OFFICE OF RATEPAYER ADVOCATES CALIFORNIA PUBLIC UTILITIES COMMISSION

Report on the Results of Operations for Pacific Gas and Electric Company Test Year 2015 Gas Transmission and Storage Rate Case

Chapter 4A Hydrotest and Vintage Pipe Replacement Programs

San Francisco, California August 29, 2014

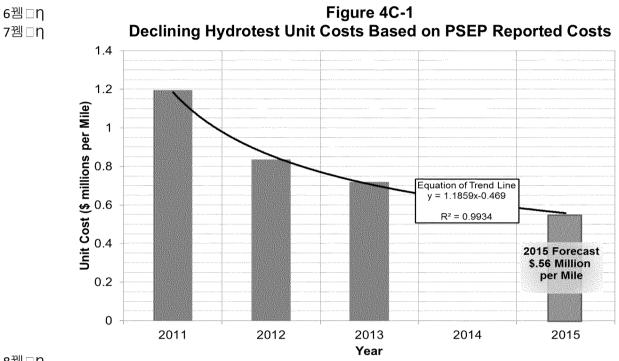
30뀀 미 The PSEP Report data not only shows lower unit costs than PG&E has

31끰 requested, based on actual PSEP costs, it also shows a clear downward trend in

1뀀 hydrotest costs between 2011 and 2013.⁶⁴ Such a trend is to be expected when a new 2뀀 program is commenced and the company experiences a learning curve. The following 3뀀 figure illustrates this trend, and extrapolates costs out two years to provide forecast 4뀀 cpsts for 2015 that take into account the likely continuation of the declining hydrotest 5뀀 cpst trend:

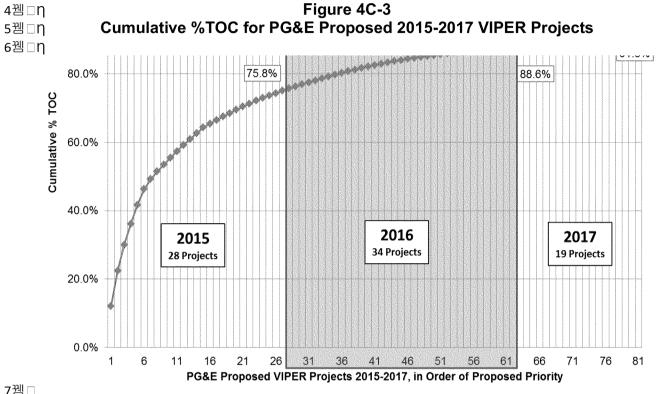
1뀀 provided and proposed unit costs for congested areas.¹⁵⁴ However, PG&E separately 2뀀 acknowledged that this will change over time.¹⁵⁵ Figure 4C-3 below confirms that this 3뀀 change will likely occur within the timespan of the current case.¹⁵⁶

1켈 대해 at while it may be reasonable to assume that the first 10 or even 20 projects are in 2켈 areas of high congestion, it is not reasonable to assume that the balance of projects in 3켈 2015, and all projects in 2016 and 2017 are in high congestion areas. This is further 4켈 supported by a map provided by PG&E in response to discovery which shows 2015 5켈 projects in urban areas like San Francisco, the East Bay, and San Jose, but 2016 and 6켈 2017 projects generally in less densely populated locations.¹⁵⁷ While this case focuses 7켈 on the 2015 test year, a reasonable forecast of pipe replacement costs must account for 8켈 how costs will decrease throughout the entire test period, and PG&E's proposed unit 9켈 copsts fail to do this.
